DATE: December 21, 2016
TO: Jeremy Schaub, Gabriel Ng Architects Inc.
FROM: Joy Navarrete, Planning Department
RE: PPA Case No. 2016-012529PPA for 2214 Cayuga Avenue and
3143 Alemany Boulevard

Preliminary Project Assessment

Date: December 21, 2016
Case No.: **2016-012529PPA**
Project Address: 2214 Cayuga Avenue & 3143 Alemany Boulevard
Block/Lot: 7146/001, 034
Zoning: Neighborhood Commercial, Cluster (NC-1) Zoning District
40-X Height and Bulk District
Area Plan: N/A
Project Sponsor: Jeremy Schaub, Gabriel Ng Architects Inc.
(415) 682-8060
Staff Contact: Christopher Espiritu – (415) 575-9022
Christopher.Espiritu@sfgov.org

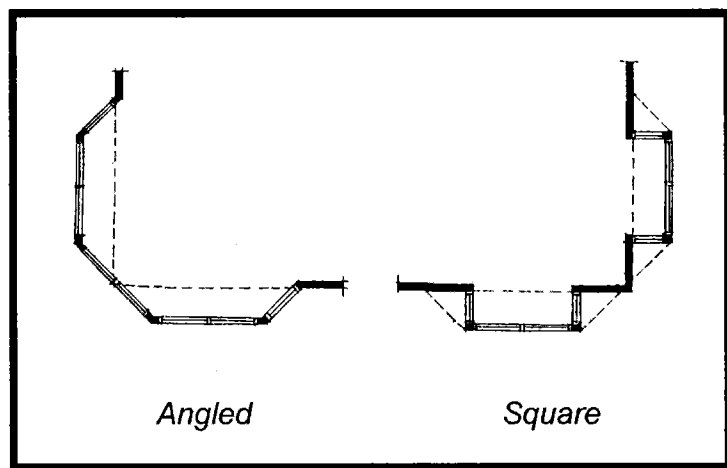
The proposed bay windows do not all appear to comply with the interior lot separation. Also, the proposed corner bay windows exceed the maximum allowed dimensions. See diagram below for what the size limits for corner bay windows are:
